NO.	DATE	REVISION
1	02/11	ADDENDUM NO. 1

WPCP REHABILITATION PROJECT

DEMOLITION

EXISTING HEADWORKS AND INFLUENT PUMP STATION LOWER PLAN AND SECTION

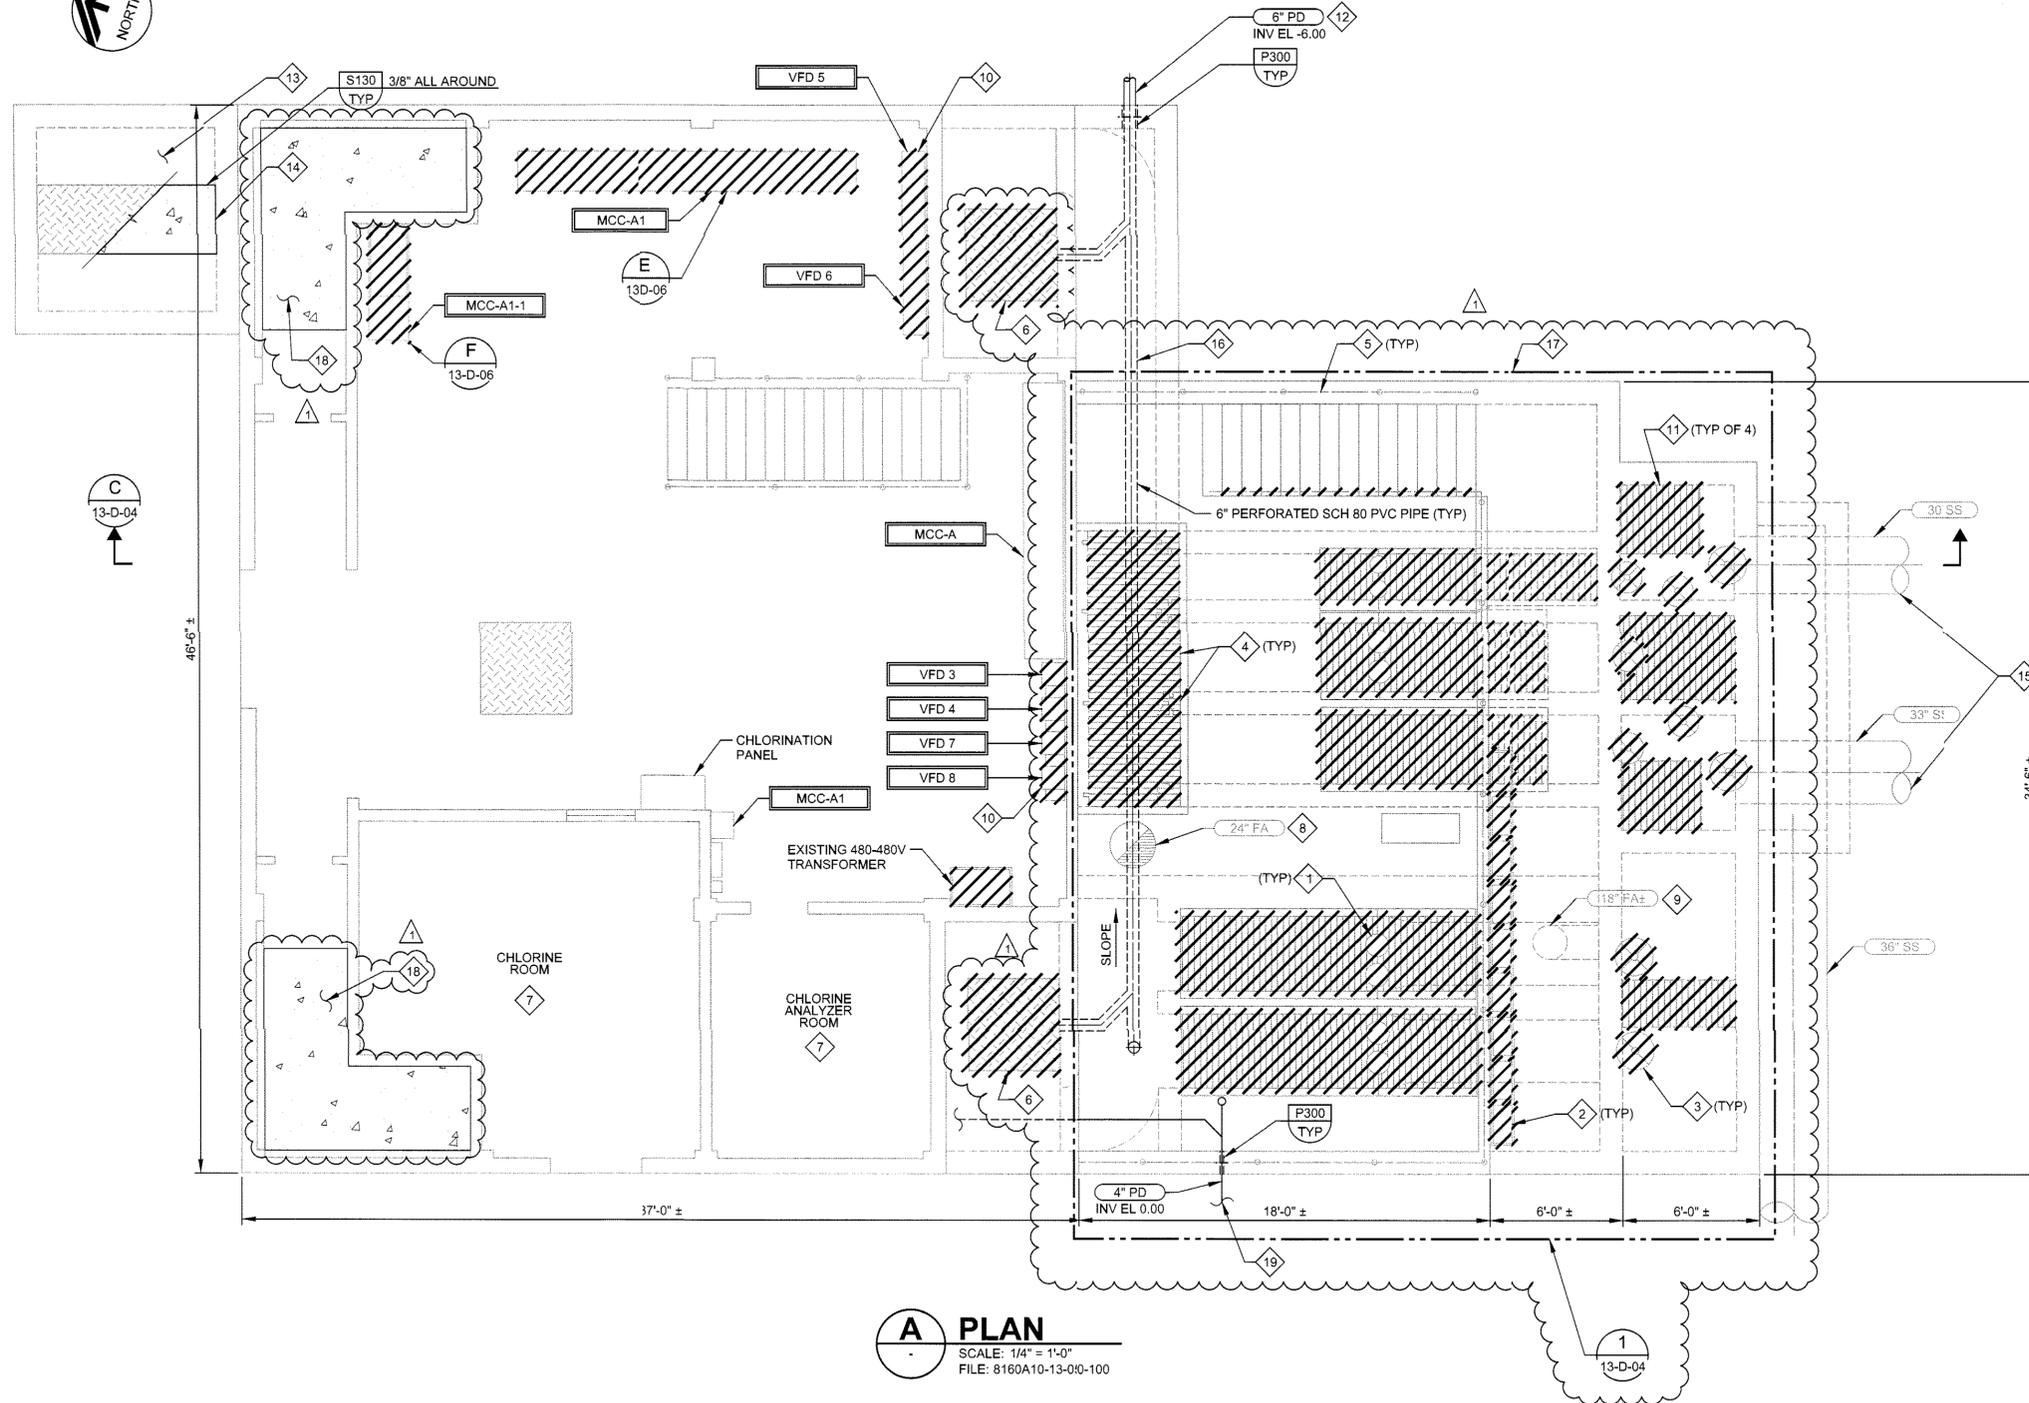
- KEY NOTES:**
- REMOVE ALL INFLUENT PUMPS AND ASSOCIATED PIPING AND VALVING.
 - BLIND FLANGE BOTH ENDS OF PIPE SPOOLS PENETRATING WET WELL WALLS. USE ALL 316 SST HARDWARE.
 - PLUG WALL PENETRATION PER TYP/S200.
 - REMOVE PIPING THROUGH WALL AND PLUG PER TYP S200.
 - REMOVE PIPING OR SLEEVE AND PLUG PER TYP/S200 OR TYP/S201, AS APPLICABLE.
 - INTERCEPT EXIST DRAIN LINES AND ROUTE NEW 4" PD LINE TO DRAIN TO MH #13. SLOPE PIPING @ 2%.
 - REMOVE ALL EXIST HANDRAIL, PIPING, LIGHTS, CONDUIT, INSTRUMENTS, AND OTHER EQUIPMENT FROM EXISTING WET WELL.
 - FILL WET WELL WITH CELLULAR CONCRETE AND CAP OPENINGS W/ 6" CONC SLAB. SEE DWG 13-D-05 FOR ADDITIONAL INFORMATION.

CITY OF SAN LEANDRO
WPCP REHABILITATION PROJECT
DEMOLITION
EXISTING HEADWORKS AND INFLUENT PUMP STATION PLAN

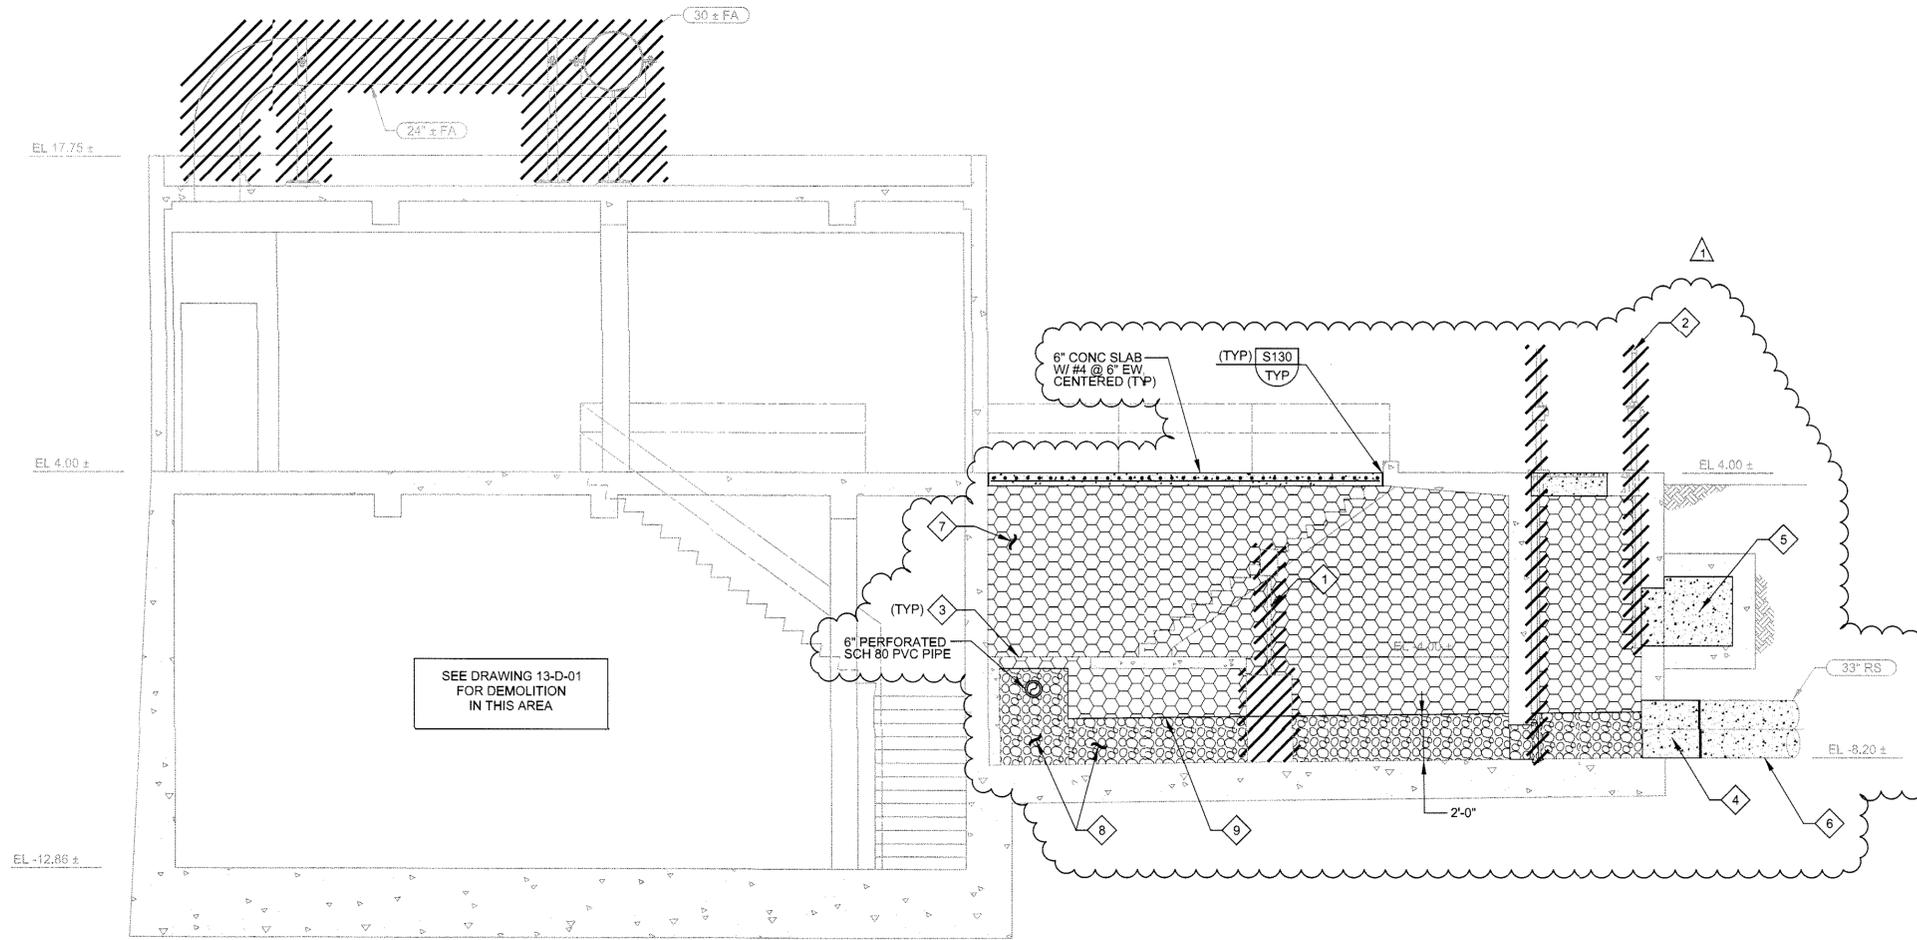
- REMOVE 8 CHANNEL MOUNTED GRINDERS.
- REMOVE GRINDER CONTR. PANELS.
- REMOVE GATES AND ACTUATORS.
- REMOVE ALUMINUM COVERS FROM CHANNELS.
- PROTECT EXIST HANDRAIL AT GRADE.

- REMOVE ALUM PLANKING. AFTER FILLING WET WELL CAP OPENING WITH 6" CONC SLAB WITH #4 @ 6" EW, CENTERED, PROVIDE 3/8" WIDE EXPANSION JOINT ALL AROUND PER TYP S130.

- EQUIPMENT IN CHLORINE ANALYZER AND CHLORINE ROOMS SHALL REMAIN OPERATIONAL AT ALL TIMES.
- REMOVE 24" FA ± FRP RISEF DUCT AND ASSOCIATED SUPPORTS BETWEEN ROOF AND TOP OF CHANNELS.

- REMOVE 18" FA± FRP FOUL AIR DUCTING CONNECTING GRINDER CHANNEL TO INFLUENT DIVERSION BOX.
- REMOVE VARIABLE FREQUENCY DRIVES AND EXPOSED CONDUIT AND CONDUCTORS ROUTED FROM VARIABLE FREQUENCY DRIVES TO THE MOTOR CONTROL CENTERS.

- REMOVE ALUMINUM COVERS ABOVE INFLUENT CHAMBER.
- SEE DWG 01-C-10 FOR PIPING CONTINUATION.
- FILL EXISTING PIPING VAULT W/ CSLM. VAULT DIMENSIONS APPROX 8' x 8' x 8'. FIELD VERIFY DIMENSIONS.

- REMOVE STEEL COVER AND CAP WITH 8" THICK CONCRETE WITH #5 @ 12" EW.
- FILL INFLUENT PIPES WITH CSLM.
- ROUTE 6" PERFORATED DRAIN PIPE THROUGH GRAVEL LAYER BELOW CELLULAR CONC FILL. TRANSITION TO SOLID WALL PIPE AT EDGE OF STRUCTURE.

- UPON COMPLETION OF DEMOLITION WORK IN INFLUENT CHANNEL AREA, BACKFILL ENTIRE VOID TO GRADE WITH CELLULAR CONC AND CAP WITH 6" CONC SLAB. SEE SECTION C/ 13-D-04 AND DETAIL 1/ 13-D-04 FOR ADDITIONAL INFORMATION.

- AFTER FILLING WET WELL CAP OPENING WITH 6" CONC SLAB WITH #4 @ 6" EW, CENTERED, PROVIDE 3/8" WIDE EXPANSION JOINT ALL AROUND PER TYP S130.
- ROUTE NEW 4" PD LINE TO TRIN TO MH #13. SLOPE PIPING @ 2%.

WPCP REHABILITATION PROJECT
 DEMOLITION
 EXISTING HEADWORKS AND INFLUENT PUMP STATION SECTION

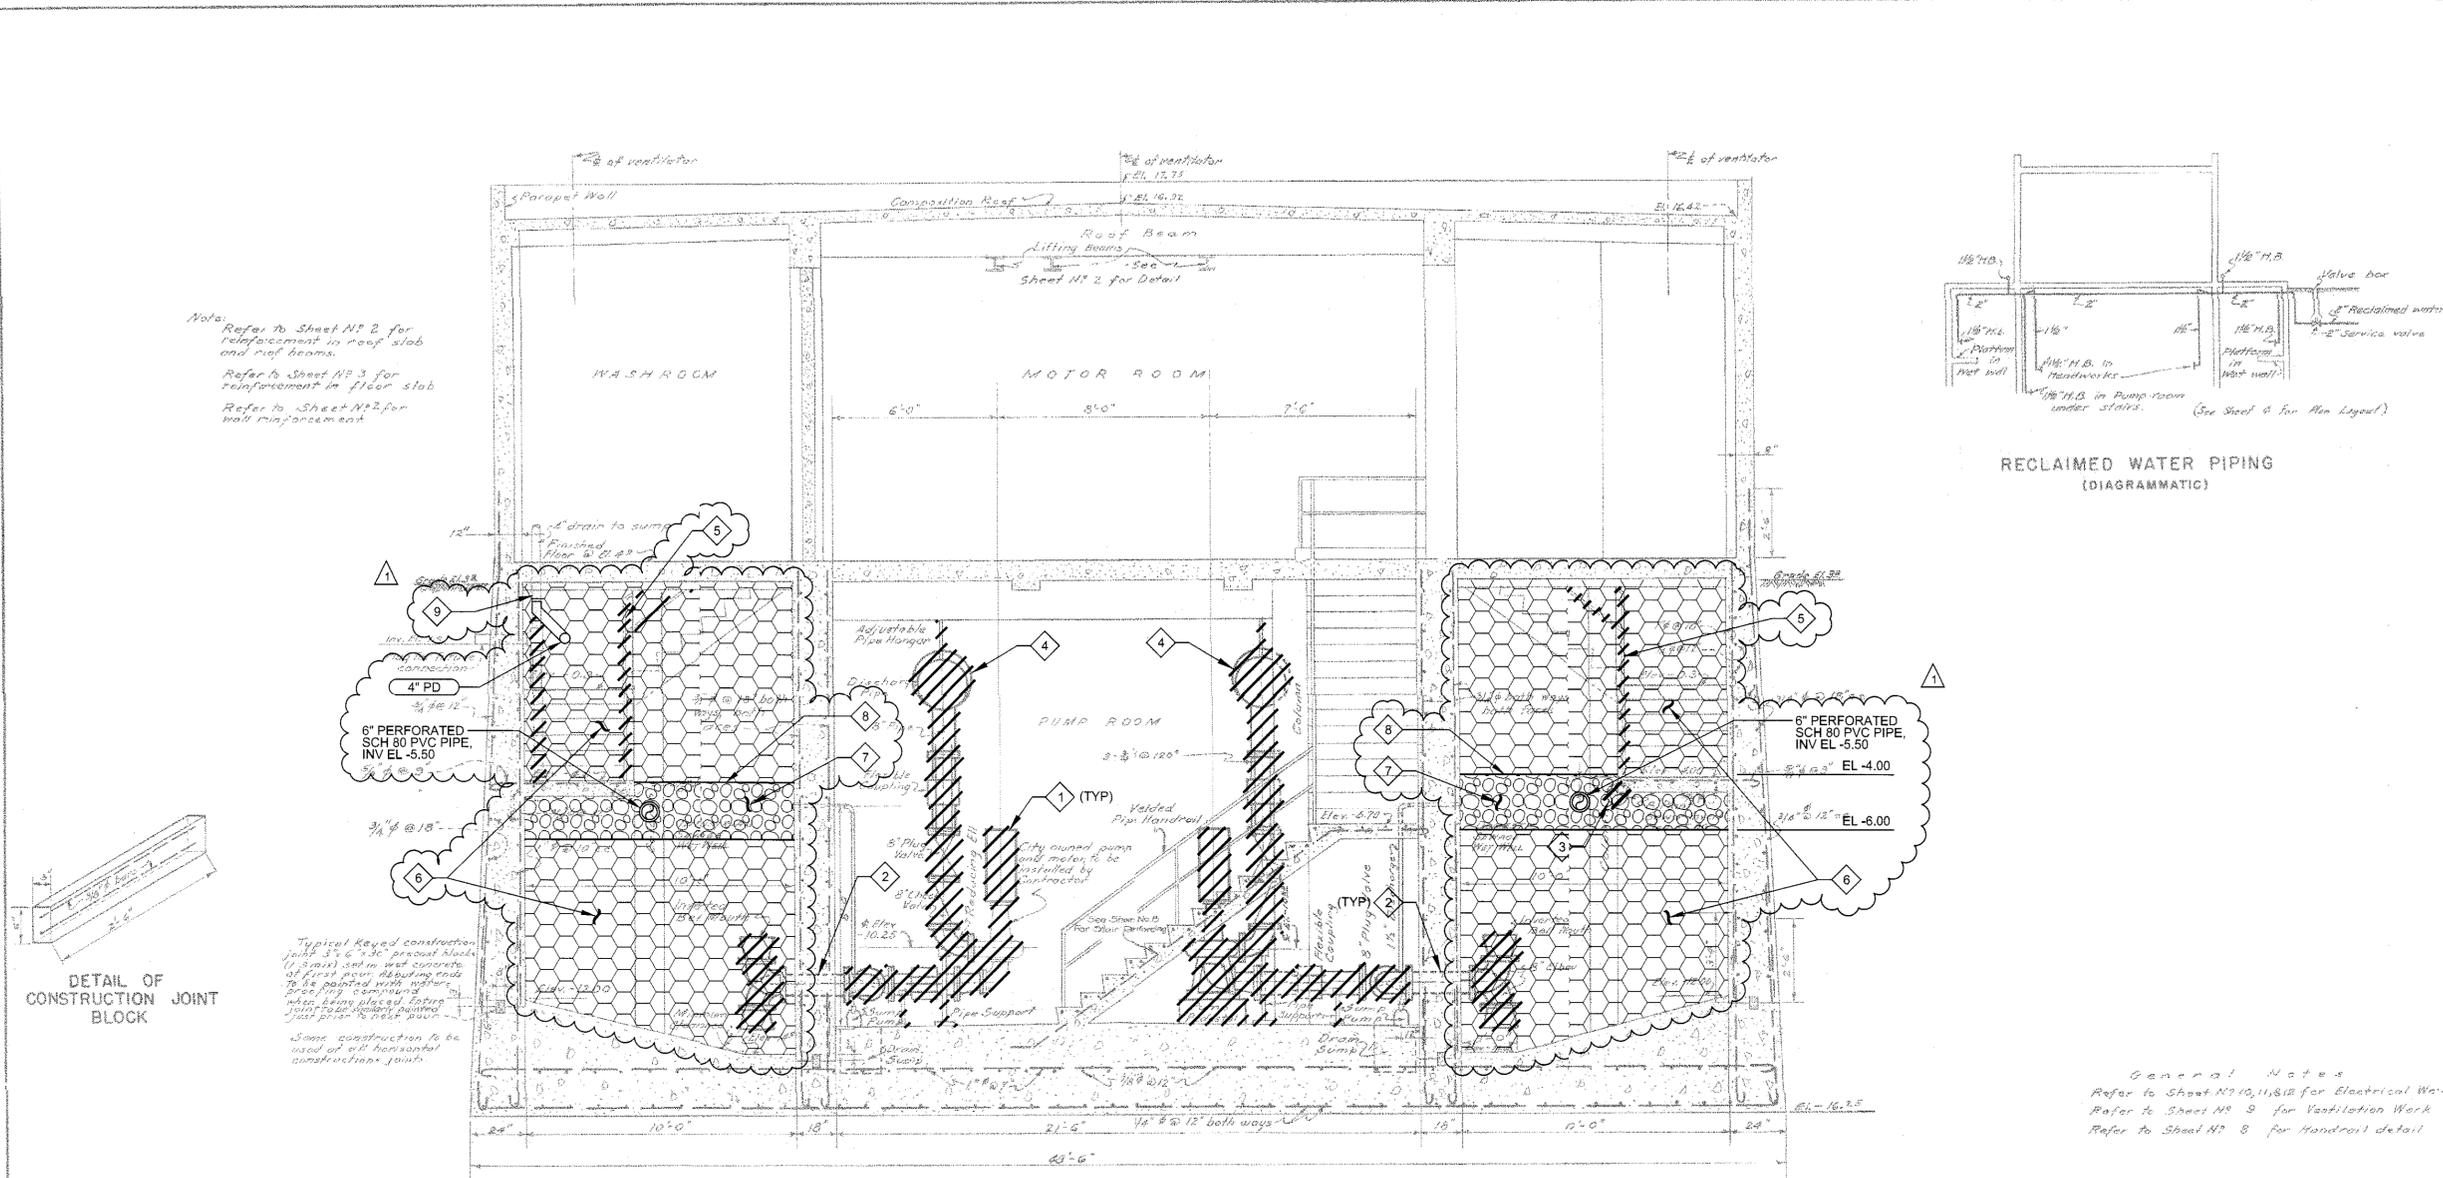
- REMOVE 8 CHANNEL MOUNTED GRINDERS FOR OWNER SALVAGE.
- REMOVE GATES AND ACTUATORS
- REMOVE ALUMINUM COVERS FROM CHANNELS.
- PLUG TWO INFLUENT PIPES PER TYP P058.
- PLUG AND FILL OVERFLOW BOX WITH CLASS "C" CONCRETE.
- FILL INFLUENT PIPES WITH CLSM.
- FOLLOWING REMOVAL OF ALL EQUIPMENT, FILL INFLUENT CHANNEL AREAS WITH CELLULAR CONCRETE TO EL 3.50. PLACE CELLULAR CONCRETE IN HORIZONTAL LIFTS NOT TO EXCEED 3'-0" IN DEPTH. ALLOW TO SET FOR MIN 6 HOURS PRIOR TO NEXT PLACEMENT.
- PROVIDE 2'-0" THICK LAYER OF LIGHT WEIGHT MATERIAL IN CHANNEL BOTTOM, BELOW CELLULAR CONCRETE FILL. AT 6" PERFORATED PIPE EXTEND MATERIAL UP TO 6" ABOVE TOP OF PIPE.
- PLACE STABILIZATION FABRIC BETWEEN LIGHT WEIGHT MATERIAL AND CELLULAR CONCRETE

LANDSCAPE
**IRRIGATION PLAN
AREA 1**

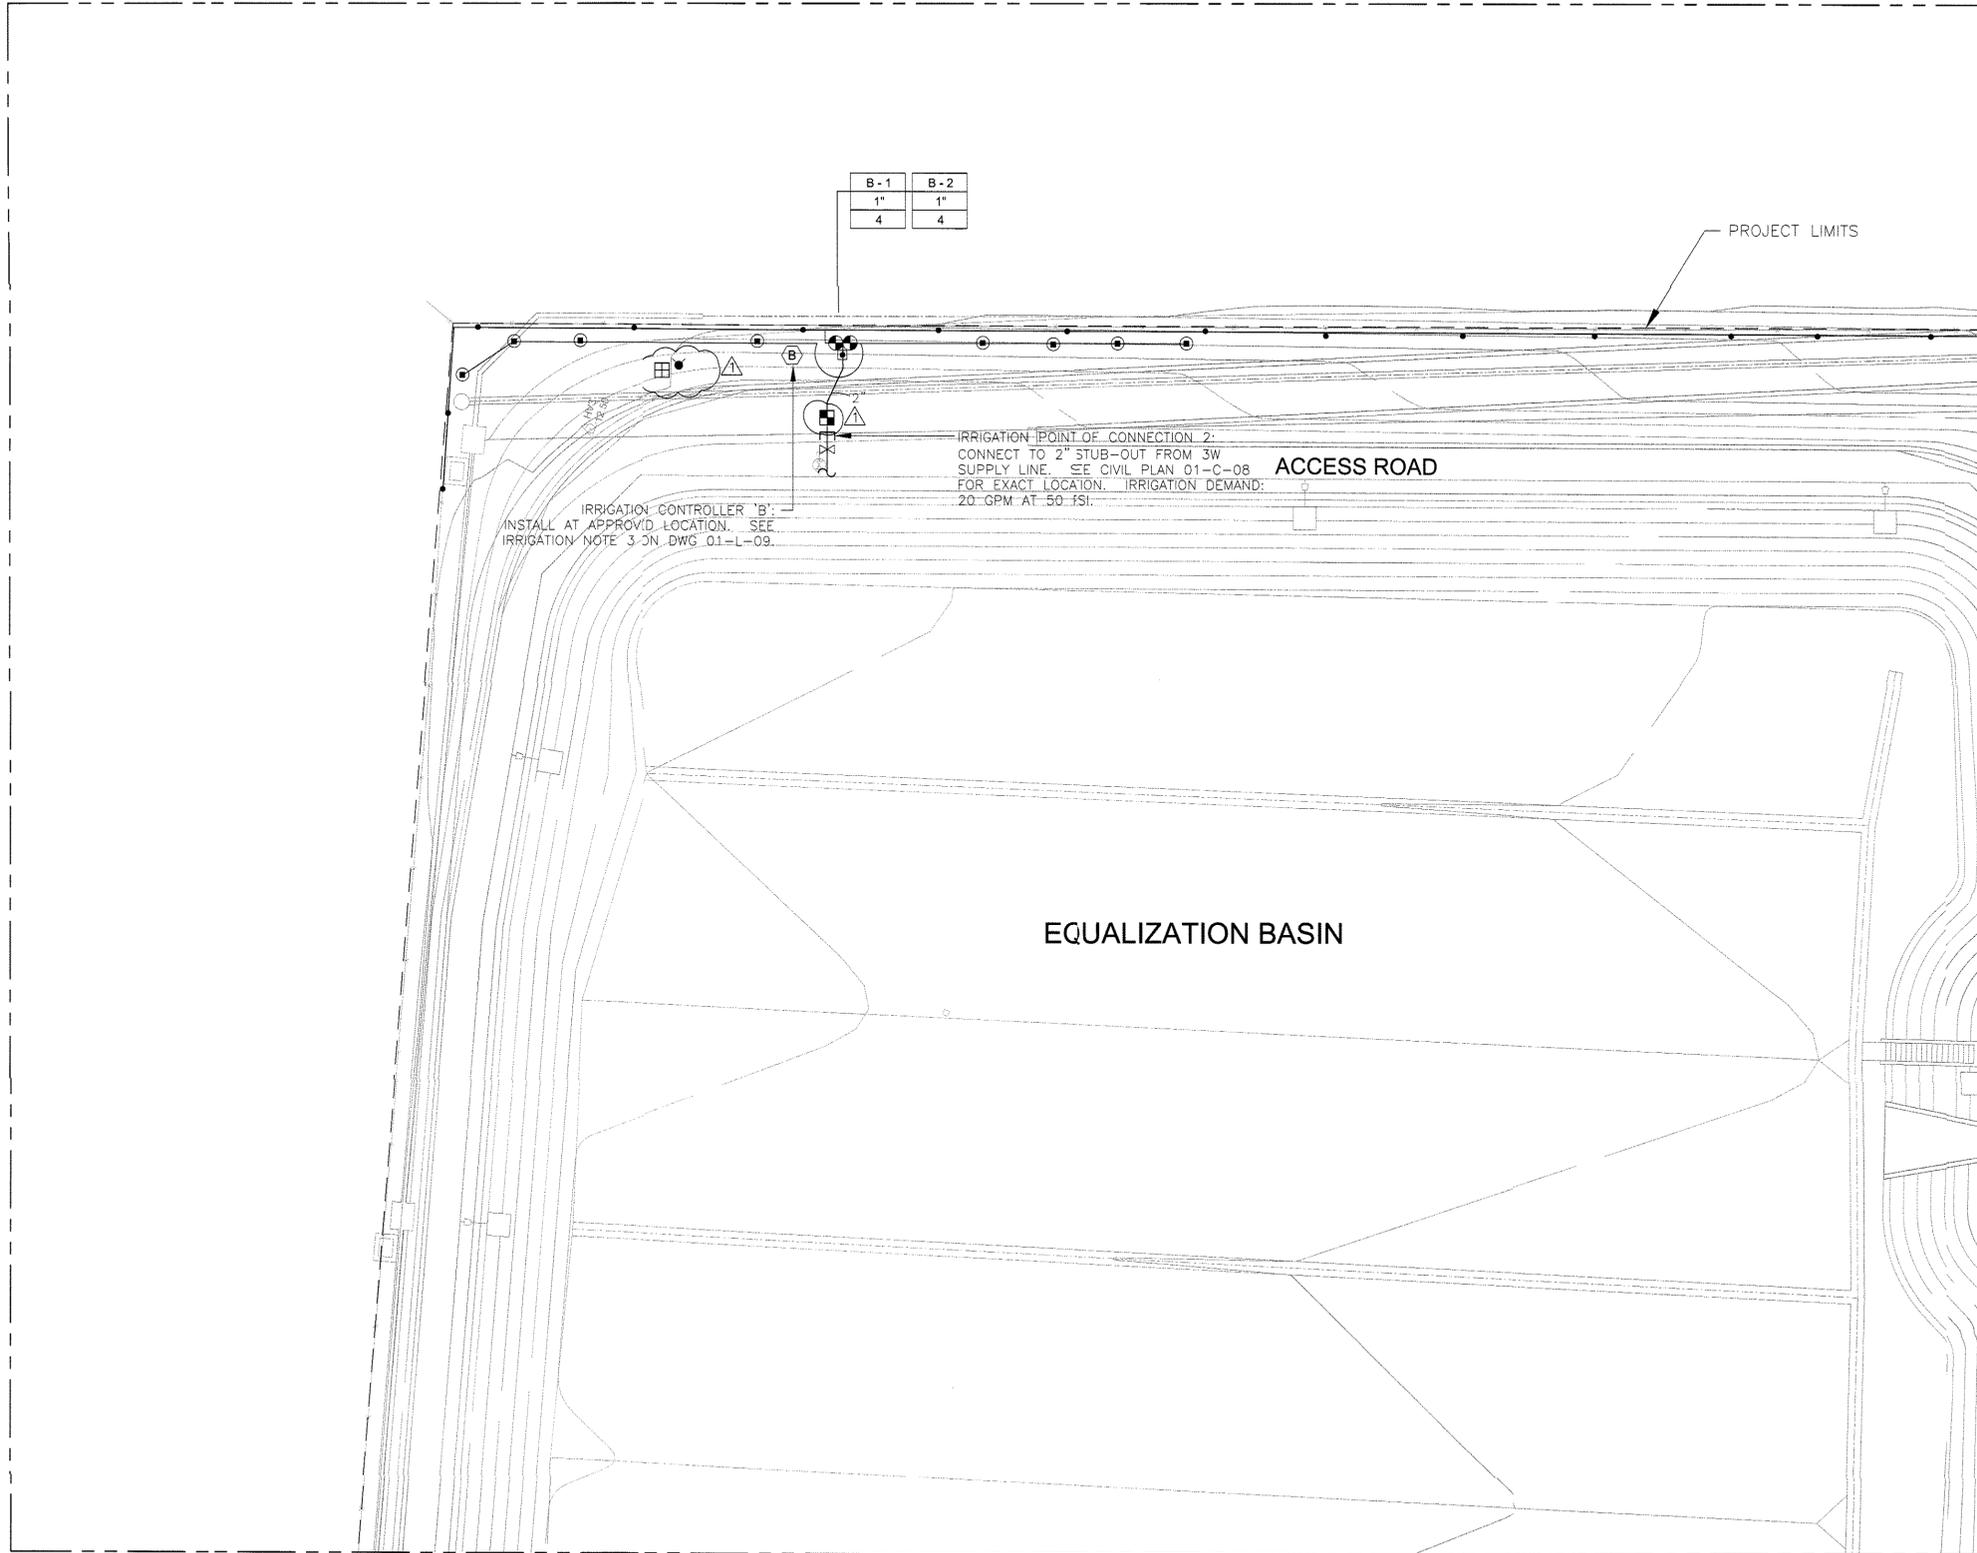
IRRIGATION CONTROLLER "B":
INSTALL AT APPROVD LOCATION. SEE
IRRIGATION NOTE 3 ON DWG 01-L-09.

IRRIGATION POINT OF CONNECTION 2:
CONNECT TO 2" STUB-OUT FROM 3W
SUPPLY LINE. SEE CIVIL PLAN 01-C-08
FOR EXACT LOCATION. IRRIGATION DEMAND:
20 GPM AT 50 PSI.
